STAFF RECOMMENDATION 1723 5th Avenue North July 18, 2018

Metropolitan Historic Zoning Commission
Sunnyside in Sevier Park
3000 Granny White Pike
Nashville, Tennessee 37204
Telephone: (615) 862-7970
Fax: (615) 862-7974

Application: New construction – infill
District: Salemtn Neighborhood Conservation Zoning Overlay
Council District: 19
Map and Parcel Number: 08108046300
Applicant: Jonathan Jones
Project Lead: Sean Alexander, sean.alexander@nashville.gov

SITE PLAN

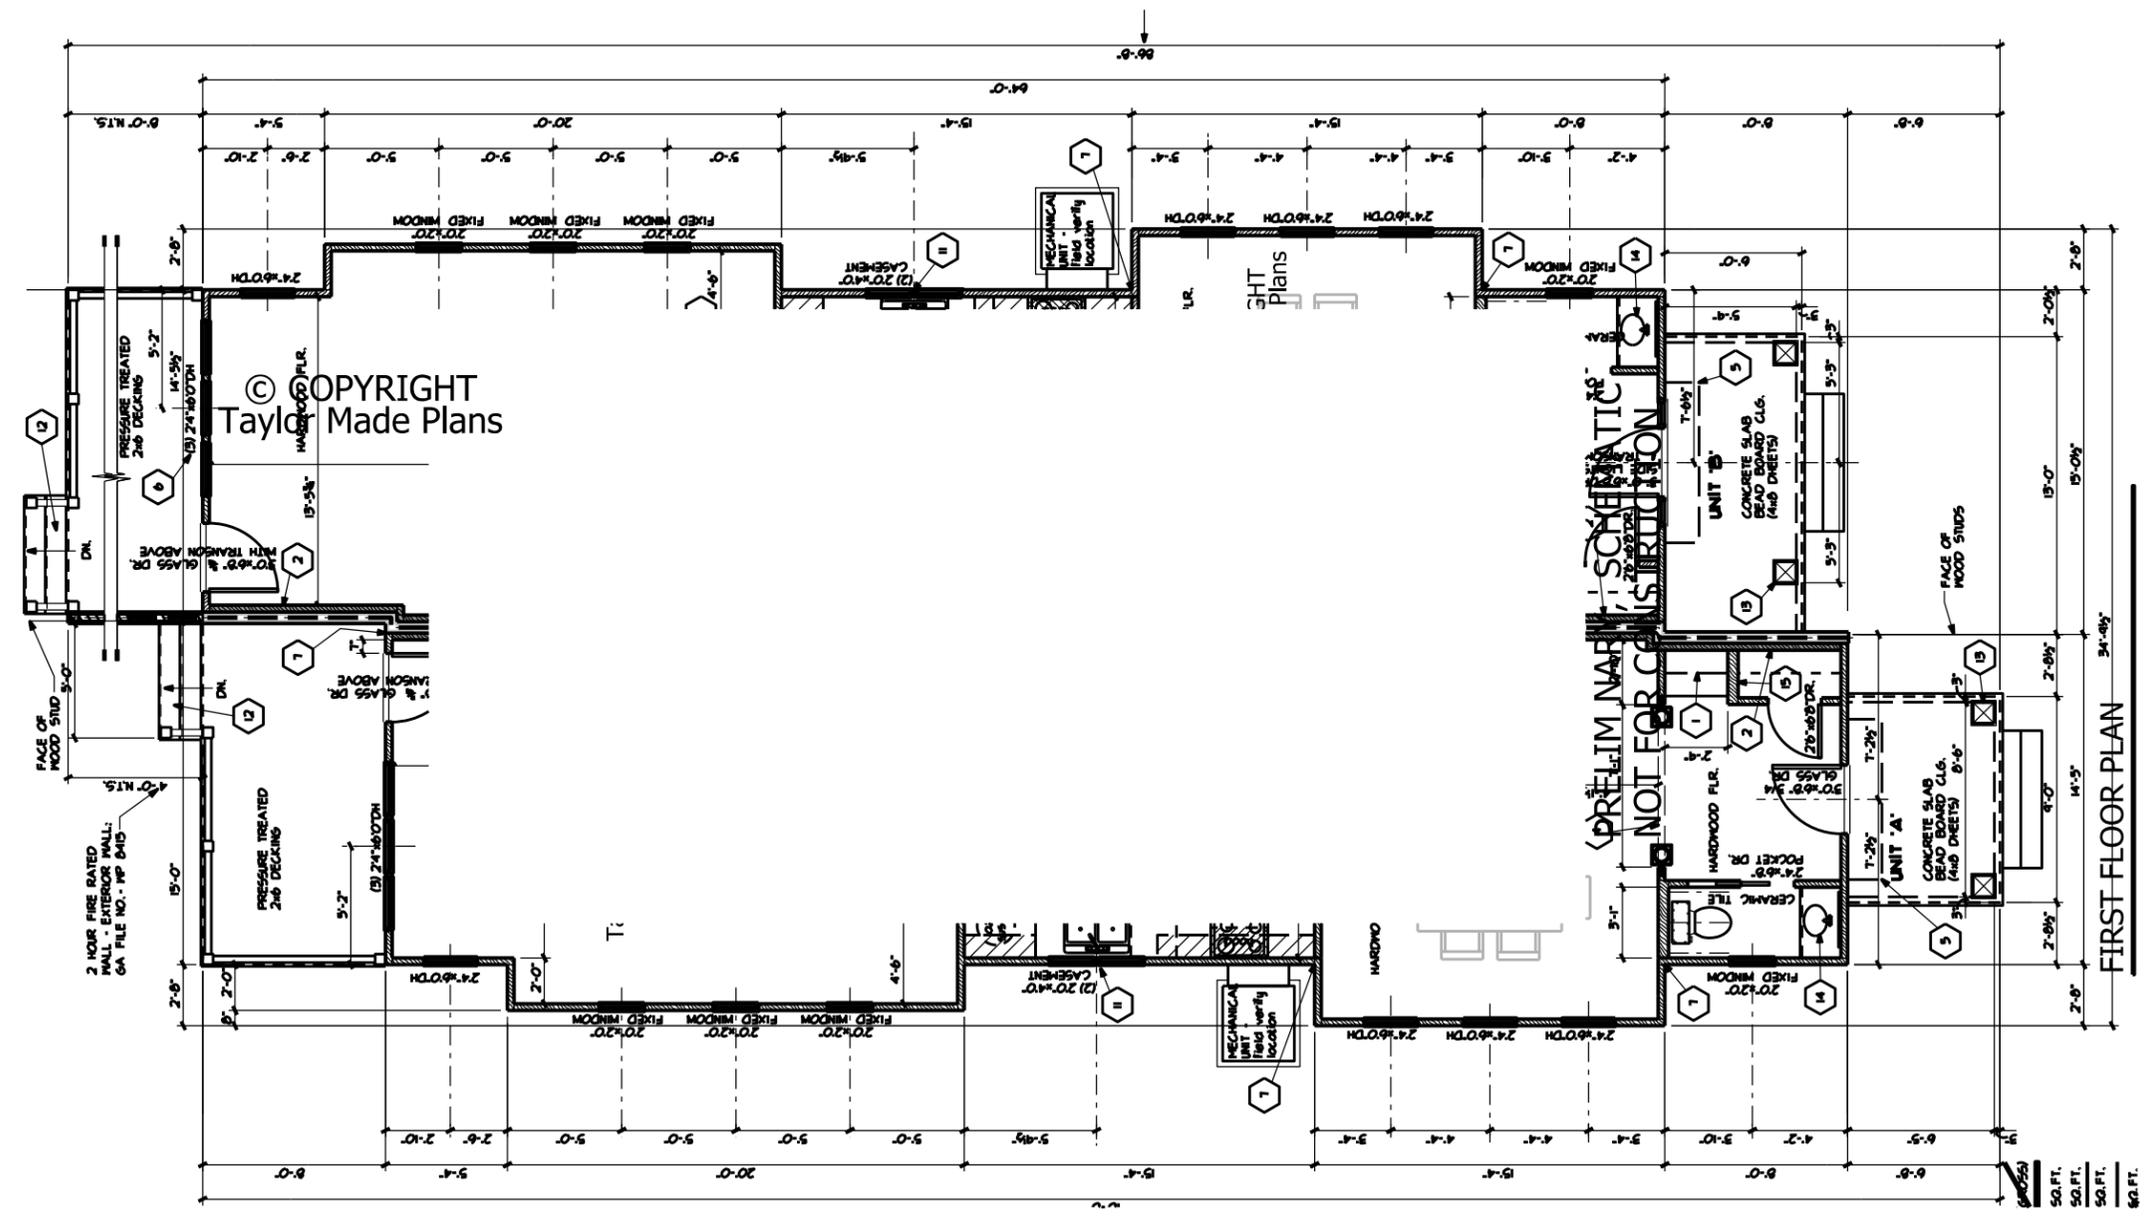
Setback & Rhythm of Spacing: The front setback for the new building is proposed to be twenty-one feet (21'). There are no buildings facing 5th Avenue North to the right, and the nearest historic building to the left is one lot away. Normally, it is appropriate for the front setback of infill to align with the closest historic buildings; however, infill that was constructed in recent years, just prior to the adoption of the overlay, dominates this portion of this block. Staff finds it to be appropriate, in this circumstance, to match the setback of the building to the left which was approved by the MHZC in 2013 and is consistent with the majority of this block face. Staff recommends as a condition of approval that the front setback be verified with an inspection prior to construction. The side setbacks will be eight feet (8') on the left and seven feet (7') on the right, which is will allow for the spacing between buildings to be compatible with surrounding houses.

Appurtenances & Utilities: The site plan does not show walkways leading from the porch to the sidewalk at the front of the property. Staff recommends that a site plan showing walkways being added is submitted before a permit is issued. Likewise, the location of the HVAC and other utilities were also not noted. With the condition that the paving location and materials are administratively approved and that the HVAC is located on the rear façade, or on a side façade beyond the midpoint of the house, Staff finds the appurtenances will be compatible with surrounding historic properties and will meet section III.I of the design guidelines.

1. The front setback shall be consistent with setbacks of the adjacent historic houses, to be verified by MHZC staff in the field;
2. The finished floor height shall be consistent with the finished floor heights of the nearby historic houses, relative to natural grade, to be verified by MHZC staff in the field;
3. The window and door selections shall be approved by MHZC Staff;
4. The roof color shall be approved by MHZC Staff;
5. A front walkway shall be added, the material to be approved by MHZC Staff; and
6. The utility connections and HVAC units shall be located behind the midpoint of the building on a non-street facing façade.

2 LEFT SIDE ELEVATION
SCALE: 1/8" = 1'-0"

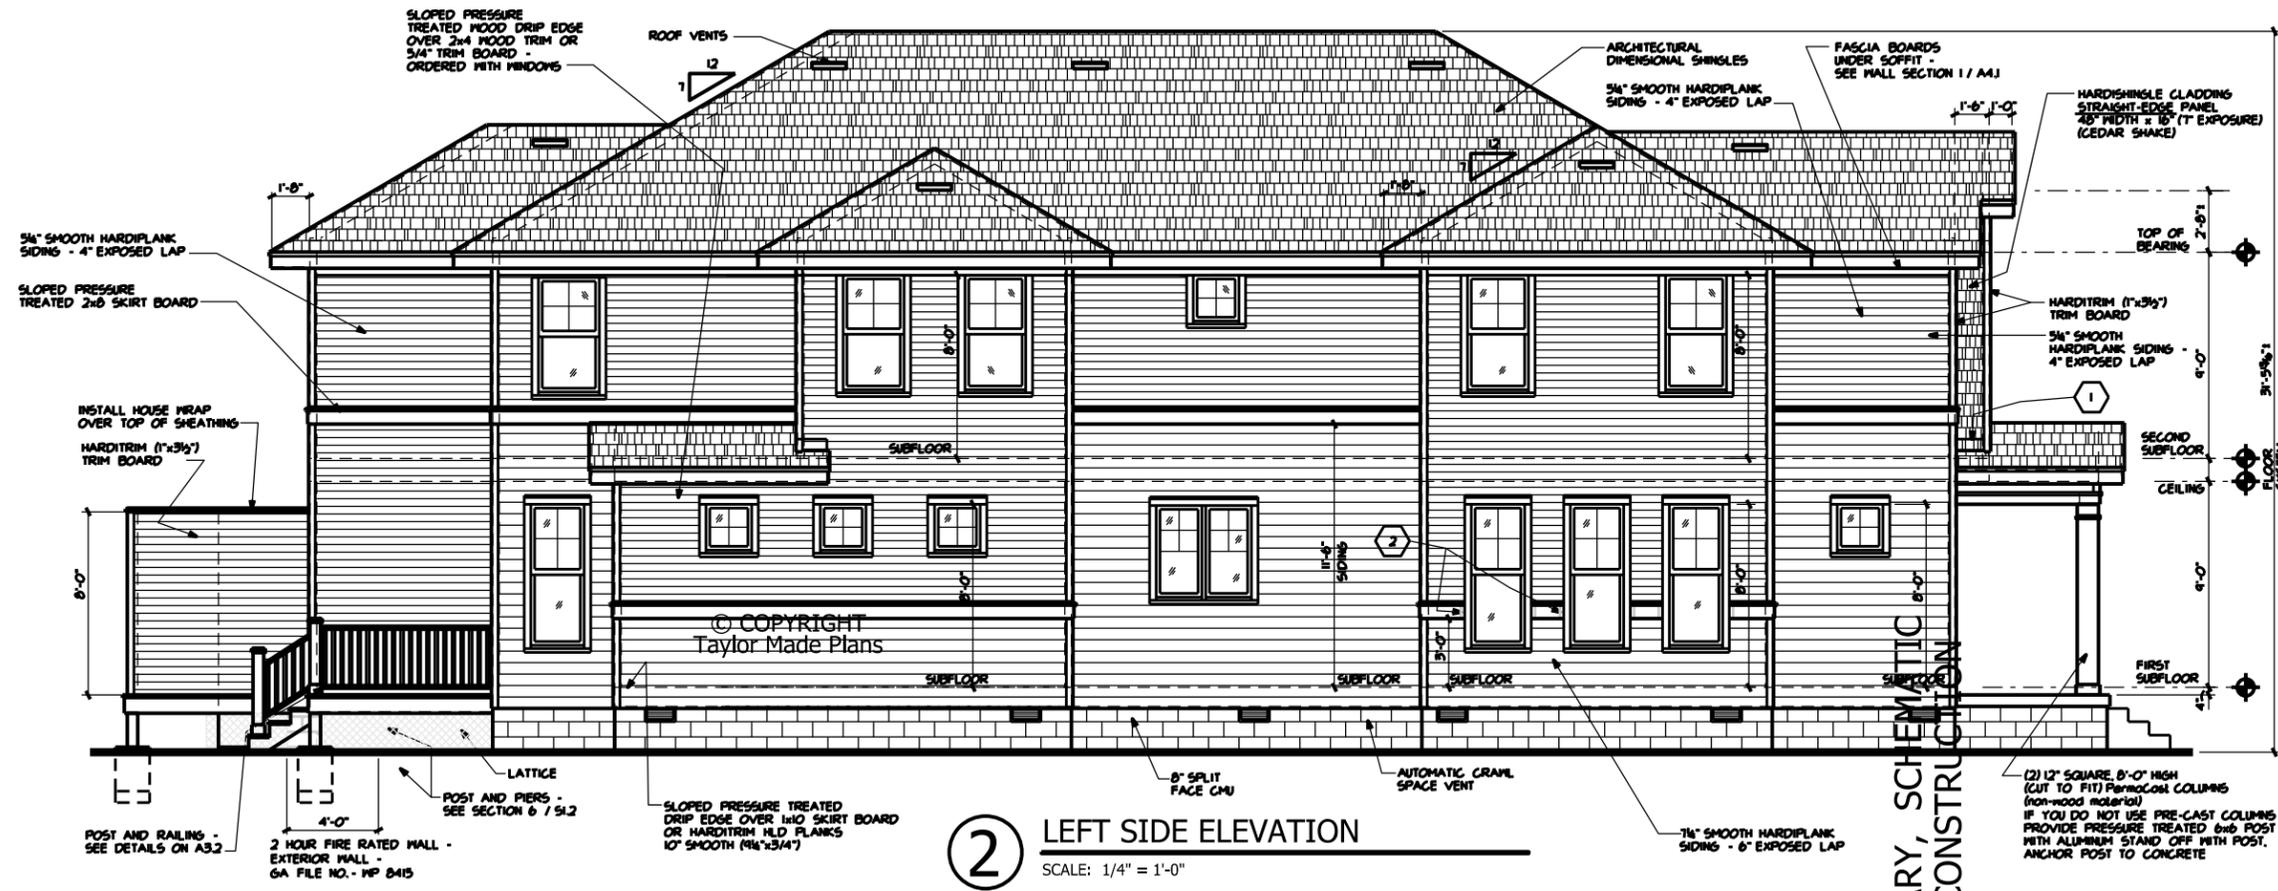
Proportion and Rhythm of Openings: The majority of window and door openings on the new building will be twice as tall as they are wide, with five smaller square windows on both the left and right facades. The vertically oriented windows will include casements and double-hung with a 4/1 sash pattern. The square windows will have a 4-light pattern. Overall, the windows will be regularly spaced without any large expanses of blank wall without an opening and with a four inch (4”) mullion between paired double-hung windows. Staff finds that the window proportions and rhythms are generally compatible with the surrounding historic context and that the project will meet section III.G of the design guidelines.
